Golf Club Greens Expansion and Practice Area
Contract #2016-06
Date: 7-14-16

1) Addendum #1

Sheet No.
14
1 of 1

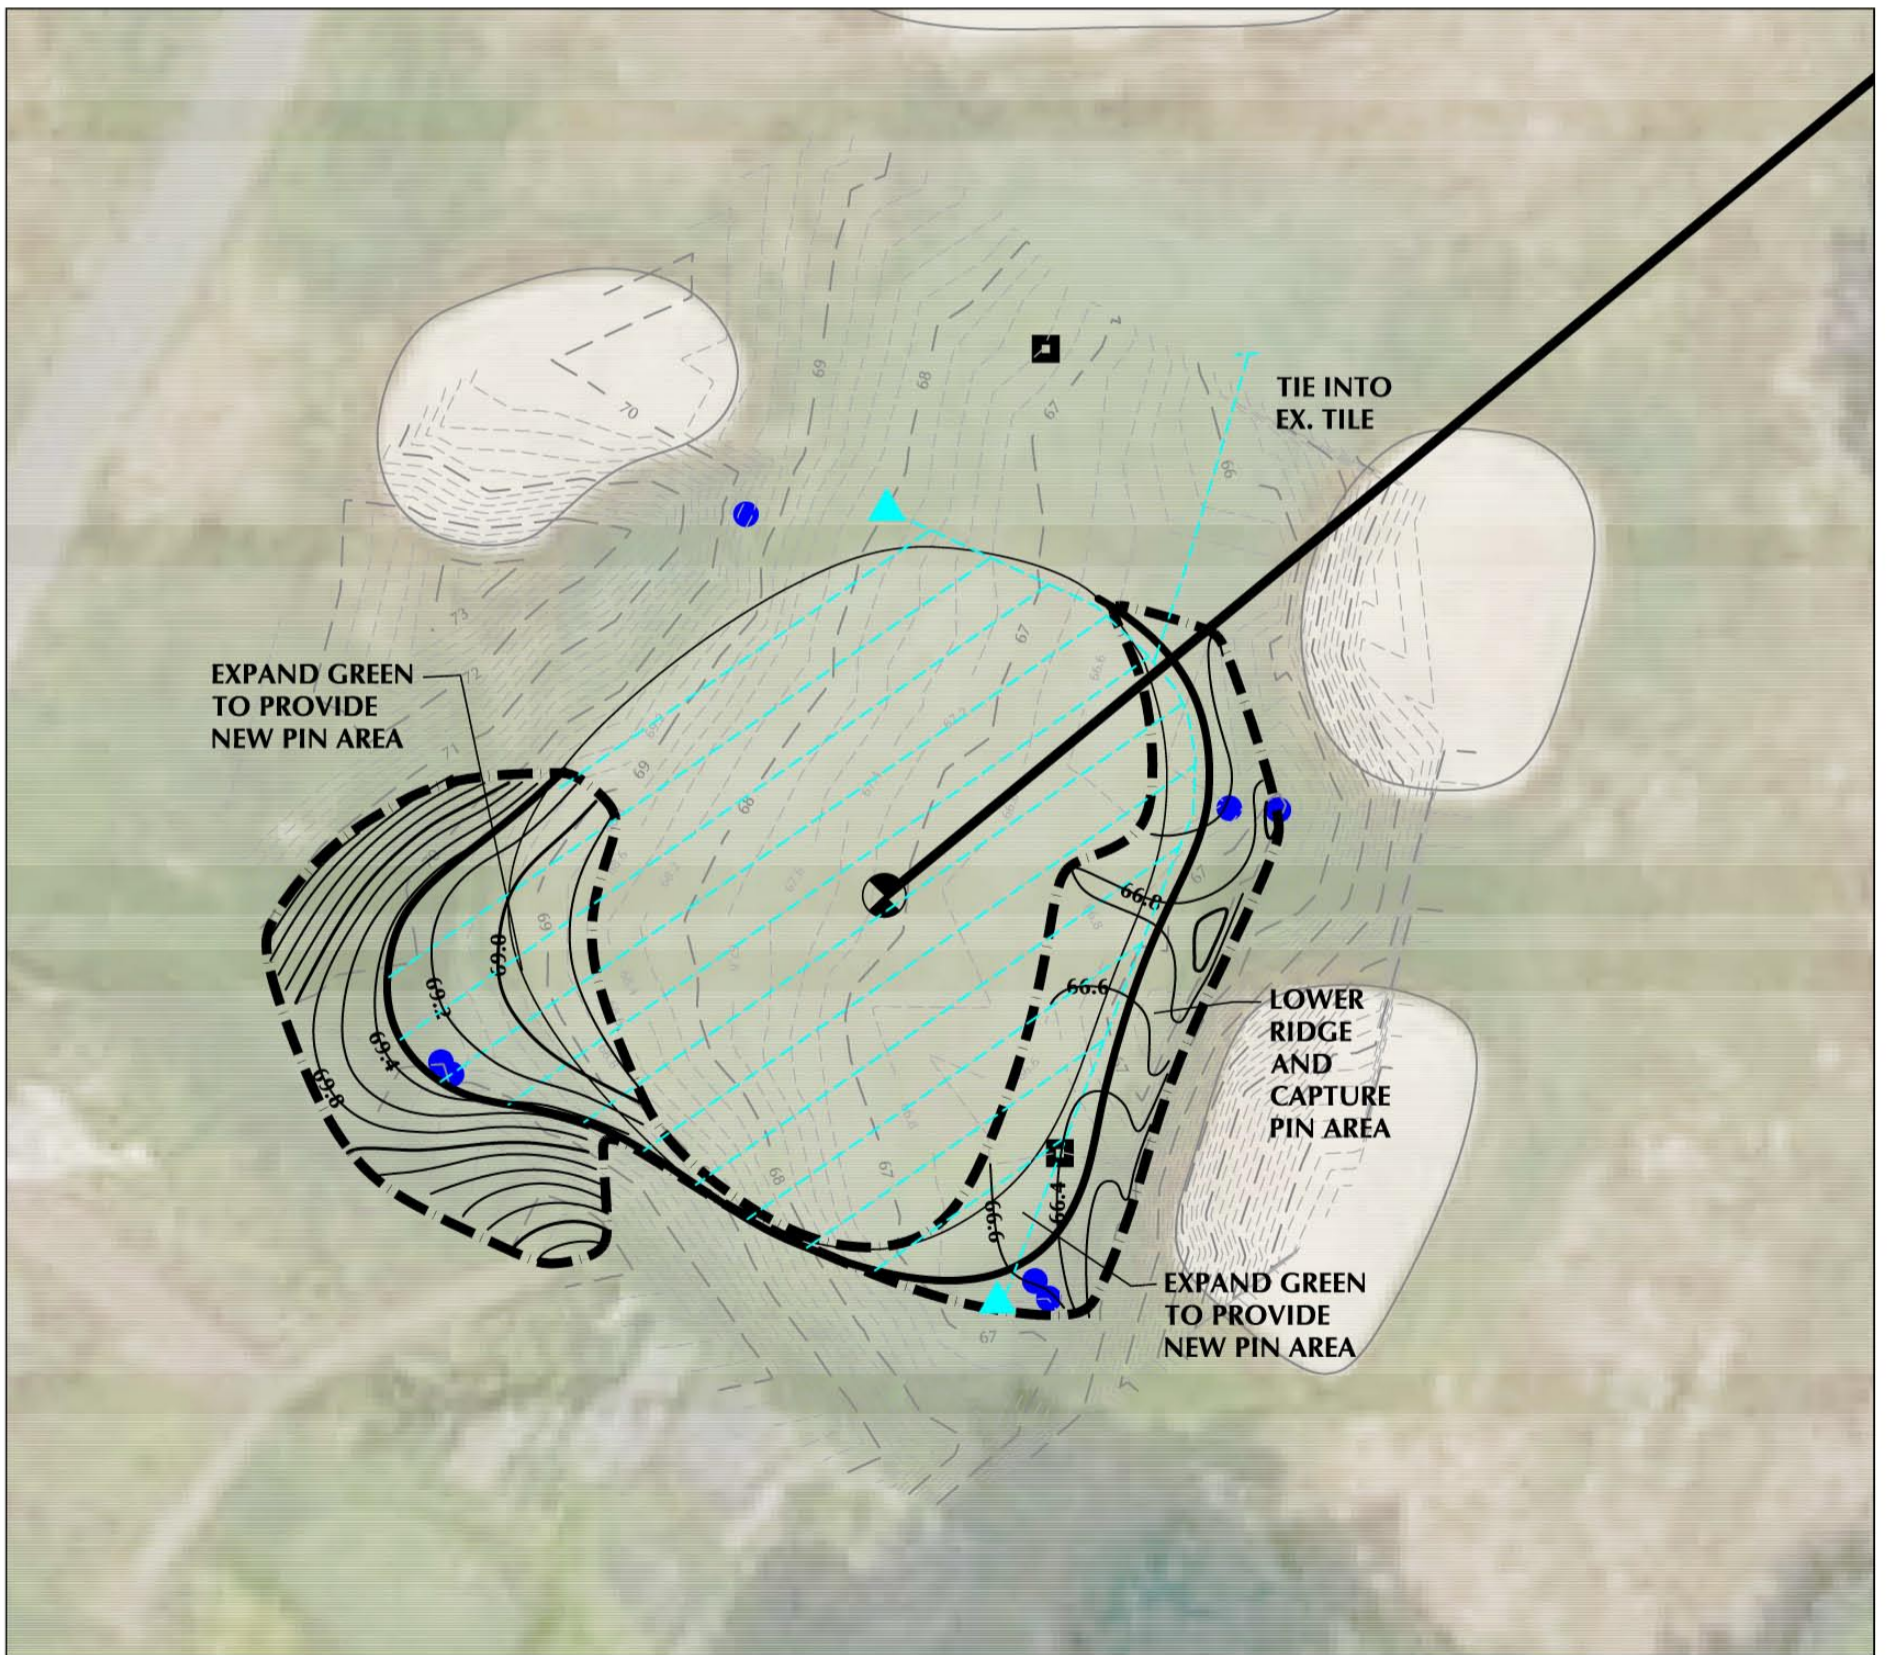
The golf club will be replacing work originally scoped for expansion and drainage installation of the 17th green complex (referenced Page 5- Section L) with expansion and drainage installation of the 14th green complex (drawings included in this addendum). Additionally, Alternative Option #2 will be removed from consideration. Finally, the deadline will be extended from July 18, 2016 at 10:00 am to Wednesday, July 20, 2016 at 10:00 am.

** The work on Hole #14 as depicted on this plan shall be substituted for Hole #17 on the original plan set dated 6-17-16. All notes and details for site preparation, grading, drainage and grassing from the original set of plans shall apply to Hole #14.
